ADDENDUM NO: 1

PROJECT: NOBLESVILLE SCHOOLS - 2024 CAMPUS PAVING IMPROVEMENTS

CONTEXT PROJECT NO: 24-1777 DATE: 5/7/2024 BY: Cameron Hull

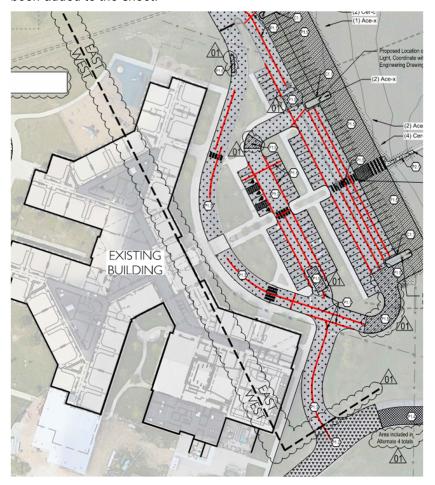
3. Q: Alternate Bids for Promise Road distinguish "east" and "west" sides of the campus (Alternates 1/2 and 3/4). Can you clarify the specific demark line we should measure to? We want to correctly calculate the intended work.

A: Yes, Context offers the following diagram to better express the intention. This line has also been added to the sheet.

PRES-101

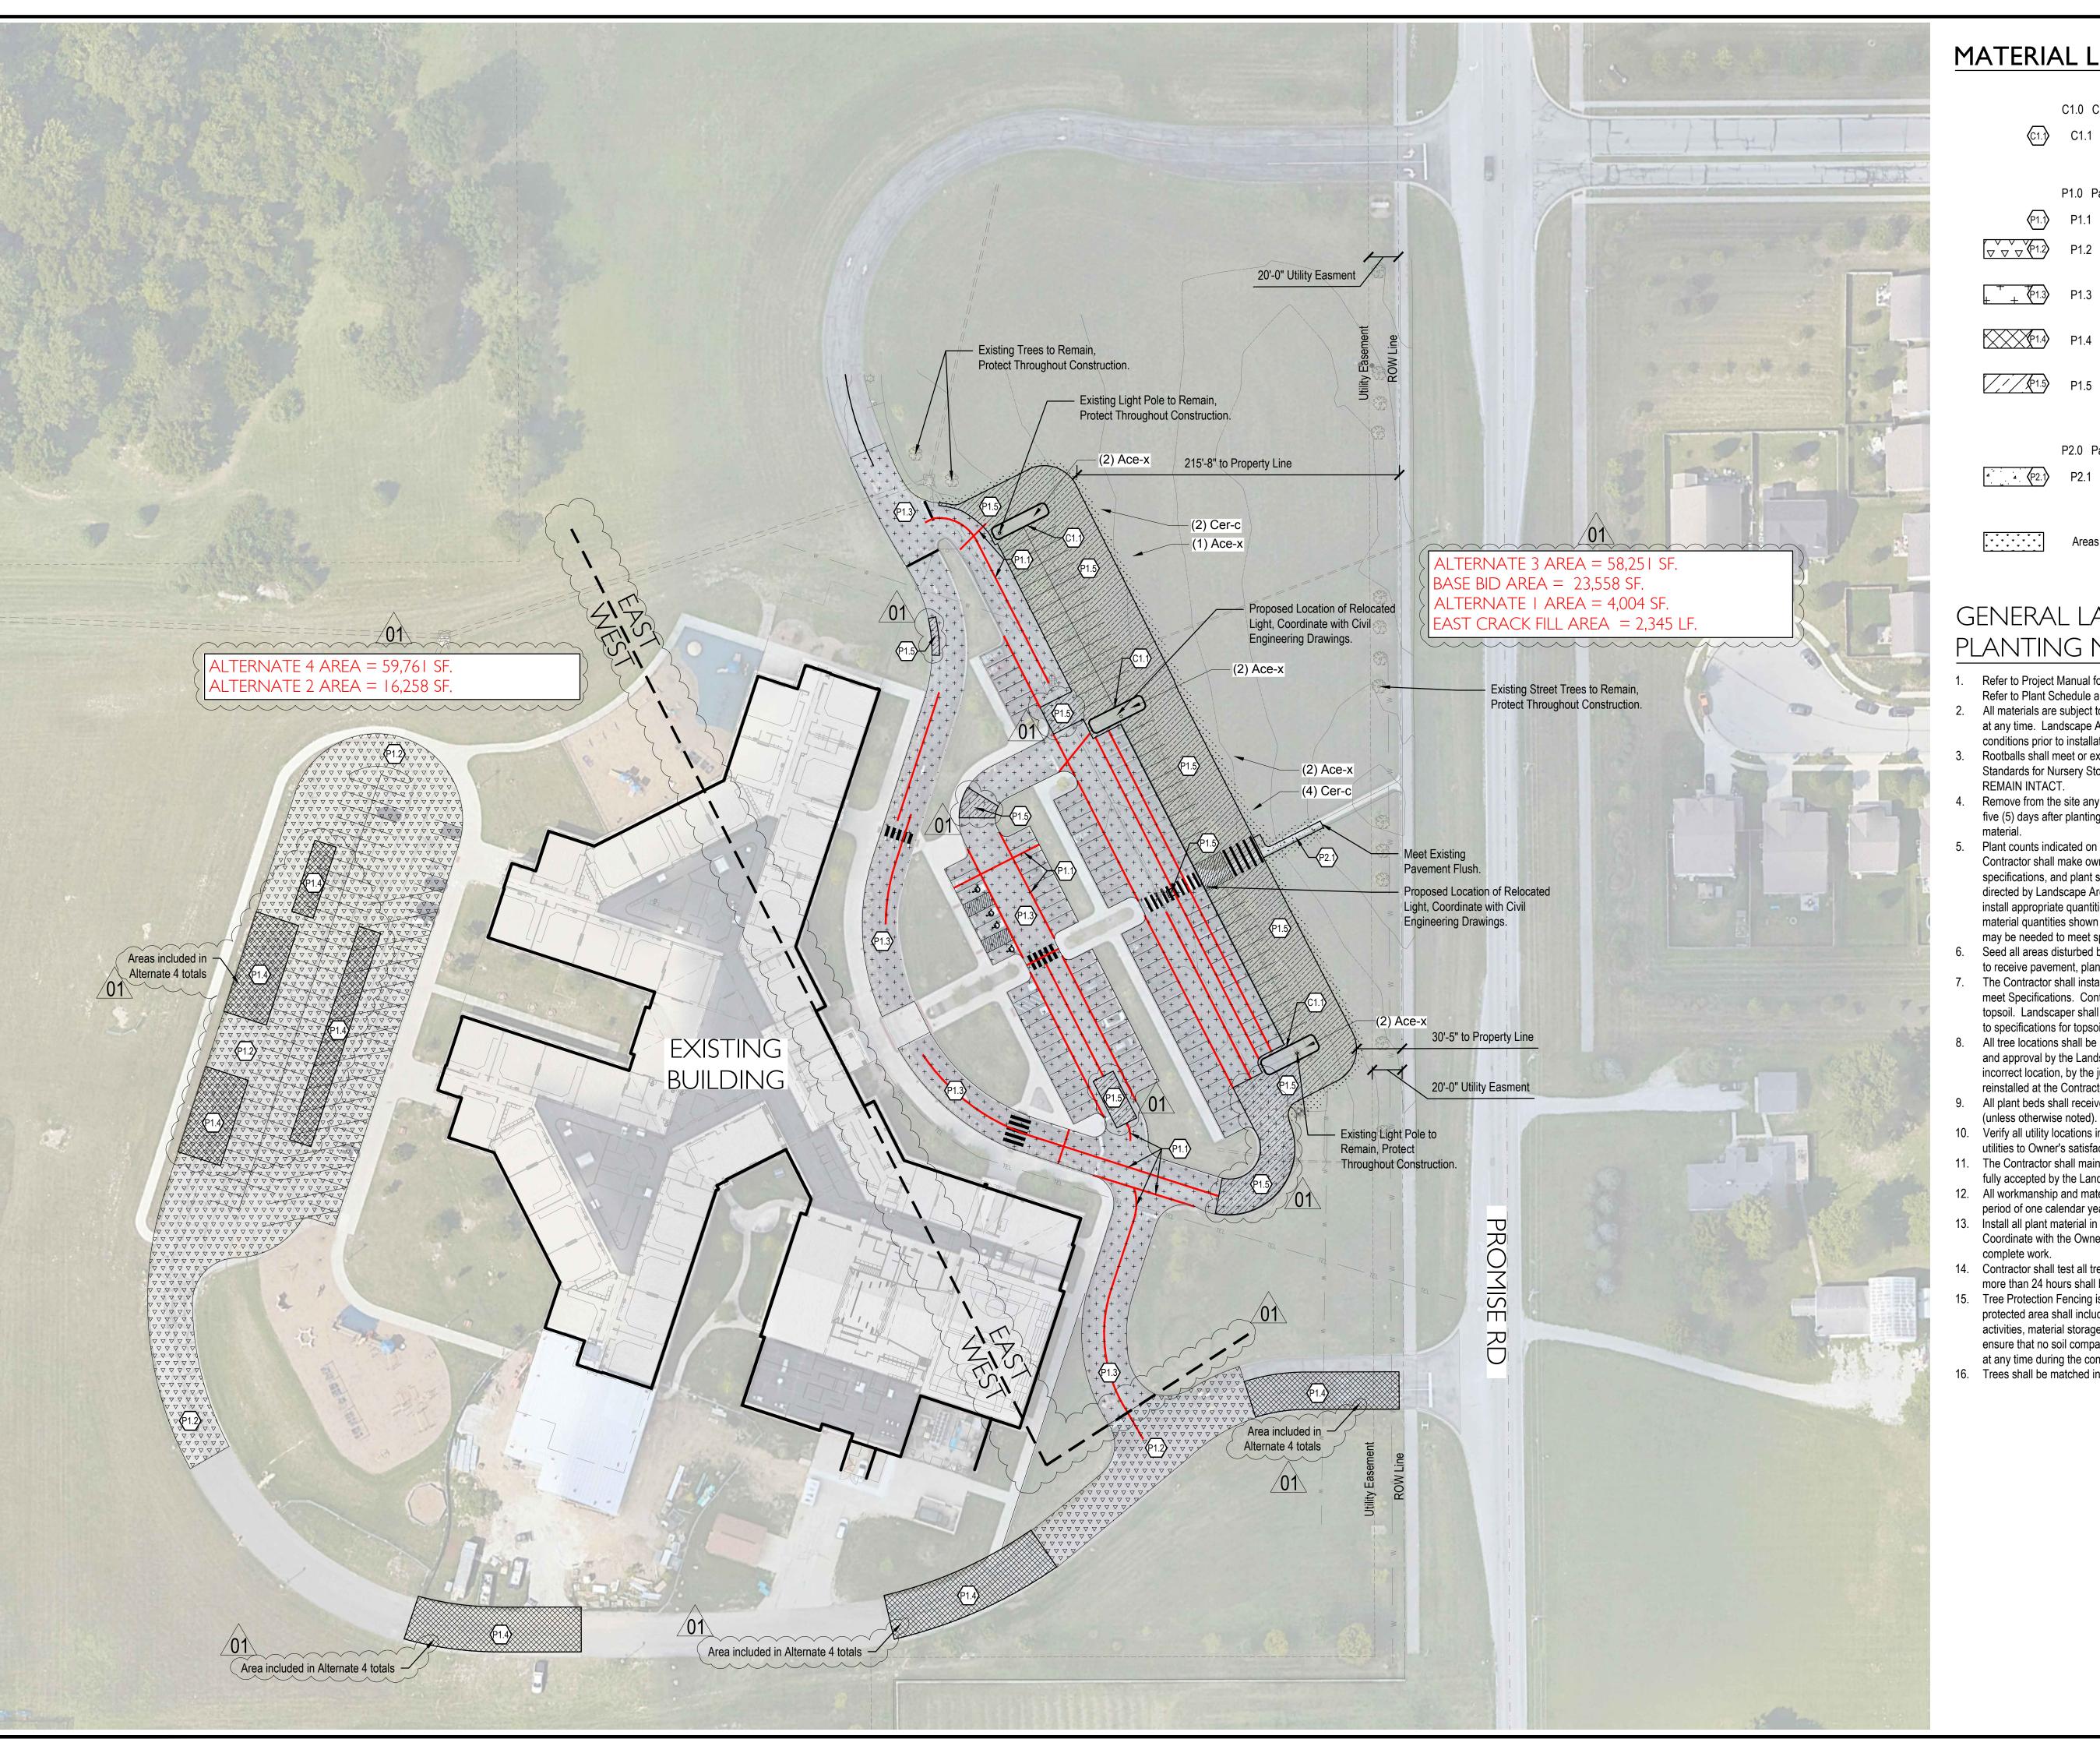
- A. PRES-101 Materials and Planting Plan Promise Road ES
 - 1. Square Footages listed in provided tables have been updated.
 - 2. Verbiage in provided tables revised to more clearly align with Alternates as listed on the Bid Form.
 - 3. Delineation line between East and West sides of the campus provided for clarity.
 - 4. Notes added to clarify scope included in Alternate 4.
- B. WRES-104 Materials and Notes Plan White River ES
 - 1. Square Footages listed in provided tables have been updated.

- 2. Q: We believe hatches may be missing from some sheets, and take-offs seem to vary from scaled Plans to provided Legends. Can you clarify?
 - A: Context has cross-checked each sheet and included clarifications within this Addendum. Quantities listed on sheets PRES-101 and WRES-104 have been revised.
